ADDENDUM NO. 5

PROJECT NO. 2036W0001Z, 2036A0024Z & TMUA-W 22-37
ARTERIAL STREET RECONSTRUCTION
GILCREASE MUSEUM RD. (N. 25TH W. AVE.)
W. ADMIRAL BLVD. TO W. PINE ST.

ADDENDUM NO. 5
TO
PROJECT NO. 2036W0001Z, 2036A0024Z & TMUA-W 22-37
ARTERIAL STREET RECONSTRUCTION GILCREASE MUSEUM RD. (N.
25TH W. AVE.) W. ADMIRAL BLVD. TO W. PINE ST.

ADDENDUM NO. 5
TO
GILCREASE MUSEUM RD.
(N. 25TH W. AVE.)
W. ADMIRAL BLVD TO W. PINE ST.
PROJECT NOS. 2036W001Z, 2036 A0024Z & TMUA-W 22-37

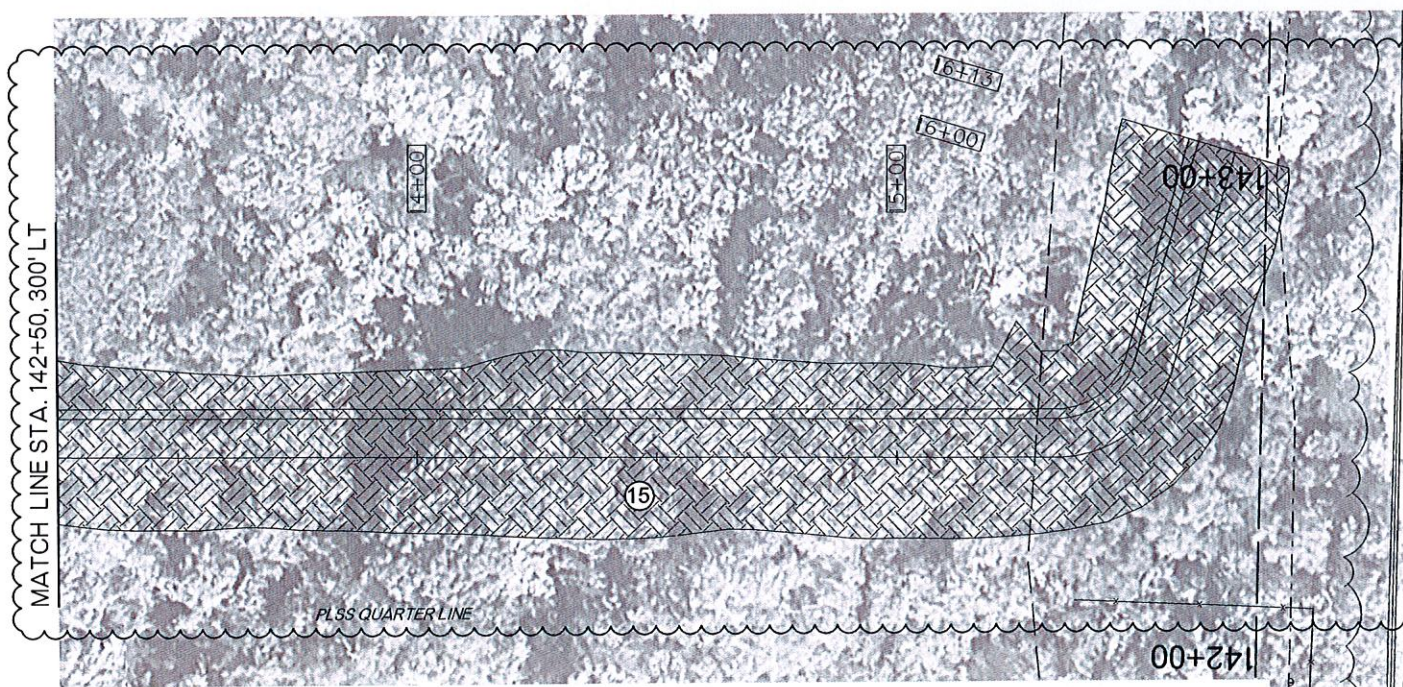
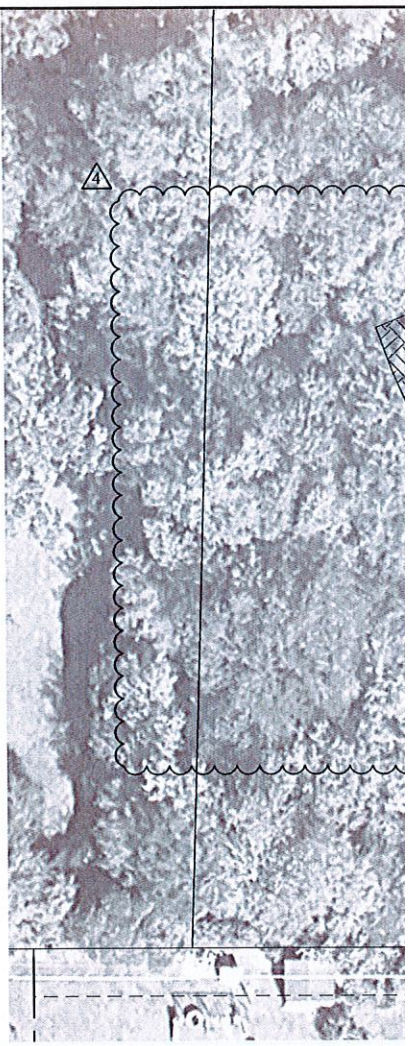
TRAFFIC OPERATIONS PAY ITEM NOTES

- COT 602** ALL CONDUIT ENDS SHALL BE REAMED AND BUSHINGS SHALL BE INSTALLED PRIOR TO PULLING ANY WIRES.
- COT 603** POLE FOUNDATIONS SHALL BE CONSTRUCTED ACCORDING TO THE APPLICABLE REQUIREMENTS OF ODOT STANDARD SPECIFICATIONS FOR DRILLED SHAFT FOUNDATIONS AS DIRECTED BY THE TRAFFIC ENGINEER.

- COT 610** THE CABINET PROVIDED SHALL BE A STRETCH CABINET MEETING THE CABINET AND DOOR HEIGHT SPECIFICATIONS OF A MCCAIN 332S CABINET. ALL OTHER DIMENSIONS SHALL MEET CURRENT COT STANDARDS AND SPECIFICATIONS

- THE TRAFFIC SIGNAL CONTROLLER PROVIDED SHALL BE AN ECONOLITE RACK MOUNT COBALT CONTROLLER IN A 332 SIGNAL CABINET OR 332S WHERE A BATTERY BACKUP IS INCLUDED. TRAFFIC SIGNAL CABINETS SHALL BE A 332S EXT RACK PER THE 2025SPEC. THE SIDES OF THE CONTROLLER CABINET SHALL BE PARALLEL TO THE STREETS. THE FRONT DOOR OF THE CABINET SHALL FACE AWAY FROM THE INTERSECTION. THE DOOR HINGES SHALL BE LOCATED ON THE SIDES OF THE CABINET FURTHEST AWAY FROM THE INTERSECTION, SO THE DOORS SWING OPEN AWAY FROM THE INTERSECTION.

- CONFLICT MONITOR SHALL BE AN EDI 2018ECLIP OR APPROVED EQUAL. AN ETHERNET PORT SHALL BE PROVIDED ON THE FRONT PANEL. THE ETHERNET PORT SHALL BE ELECTRICALLY ISOLATED FROM THE MMU ELECTRONICS AND SHALL PROVIDE MINIMUM OF 1500 VRMS ISOLATION. THE CONNECTER SHALL BE AN RJ-45 EIGHT PIN CONNECTOR. AN HTML BASED CAPABILITY SHALL BE PROVIDED IN THE MONITOR TO CONFIGURE THE NETWORK PARAMETERS OF THE MMU ETHERNET PORT USING A STANDARD HTML BROWSER. ALL DISPLAY INDICATORS SHALL BE MOUNTED ON THE FRONT PANEL OF THE SIGNAL MONITOR AND SHALL BE WATER CLEAR, T-1 PACKAGE, SUPER BRIGHT TYPE LEDS. ALL FAULT LEDS SHALL BE RED EXCEPT THE PWR INDICATOR WHICH SHALL BE GREEN. A SEPARATE RED, YELLOW AND GREEN INDICATOR SHALL BE PROVIDED FOR EACH CHANNEL.

- INCLUDE 2-19" RACK SHELVES, THAT ARE CHATSWORTH PRODUCTS PART NUMBER 10758-701 OR APPROVED EQUAL, IN ADDITION TO WHAT IS OUTLINED IN COT 610 SPECIFICATION. RACKS SHALL BE DESIGNED TO HOLD SMALL PERIPHERAL EQUIPMENT IN A CENTRAL LOCATION. EACH SHELF TYPICALLY HOLDS TWO UNITS AND ALLOWS A CONVENIENT CABLE RUN DOWN THE INSIDE OF THE RACK CHANNEL. RACK SHALL HOLD EQUIPMENT UP TO 17.35"W X 9.82"D AND MADE OF STRONG, LIGHTWEIGHT ALUMINUM THAT CAN SUPPORT UP TO 50 LB.

- THE CONTROLLER CABINET DOORS SHALL BE EQUIPPED WITH A CL-TC1 GEN 2 CYBERLOCK CYLINDER AND EITHER A15481RS CCL TRAFFIC CABINET LOCK RH, OR A15481LS CCL TRAFFIC CABINET LOCK LH. THE CONTRACTOR WILL BE REQUIRED TO PURCHASE A CYBERKEY BLUE 3 THAT SHALL BE PROGRAMMED BY TRAFFIC OPERATIONS AT 4015 N HARVARD AVE, TULSA, OK 74115.

- THE BATTERY BACKUP SYSTEM SHALL BE ECONOLITE ZX2000-48 SUPER CAPACITOR BATTERY MODULES AND DBLMXU-48 SERIES DOUBLE CONVERSION UPS.
- THE CONTRACTOR SHALL DELIVER THE SIGNAL CABINET FULLY WIRED AND READY FOR INSTALLATION TO THE COT TRAFFIC OPERATIONS DIVISION FOR INSPECTION AND APPROVAL PRIOR TO INSTALLATION. COT WILL NOTIFY THE

COT 613 THE AUDIBLE PUSH BUTTON SHELF MOUNT CONTROL UNITS SHALL BE INSTALLED IN ACCORDANCE WITH ALL REQUIREMENTS, AND WITH ALL WEATHER SURFACING MATERIALS MOUNTED 42 INCHES ABOVE THE CORRESPONDING CROSSWALK. IF NEEDED, THE EXTENDER ARM SHALL BE USED. ALL PUSH BUTTONS ARE LOCATED AT THE CORRESPONDING CROSSWALK. ALL MESSAGES SHALL BE USED AND PROGRAMMED WITH THE FOLLOWING:

COT 614 HINGES SHALL BE LOCATED ON THE 4-SECTION SIGNAL HEAD AND 5-SECTION SIGNAL HEAD.

"THIS PAY ITEM SHALL INCLUDE (INSERT #) OF THE 4-SECTION "DOGHOUSE" STYLE BACKPLATE PROJECT SHALL BE ALUMINUM NON-REFLECTIVE BLACK FINISH STYLE AS APPROVED BY THE TRAFFIC ENGINEER. A 2 INCH WIDE RETRO-REFLECTIVE TAPE, OF THE BACKPLATES.

THE PEDESTRIAN SIGNAL HEAD OR APPROVED EQUAL SHALL BE INSTALLED ON THE POLES AT THE CROSSWALK.

COT 625 THIS PAY ITEM INCLUDES TRAFFIC SIGNAL EQUIPMENT TO THE CITY OF TULSA, HARVARD AVE, WHICH IS TRAFFIC SIGNAL ITEMS INCLUDING POLES, SIGNAL HEADS, PEDESTRIAN CONTROLLER CABINET ASSEMBLIES, SIGNS, MAST ARM SIGNS, AND OTHER TRAFFIC SIGNAL EQUIPMENT. THE CONTRACTOR SHALL BE RESPONSIBLE FOR CONDUIT AND WIRE WHICH SHALL BE INSTALLED BELOW GROUND LEVEL OF THE ARM POLES, AND ALL OTHER TRAFFIC SIGNAL EQUIPMENT POLES ARE TO BECOME THE
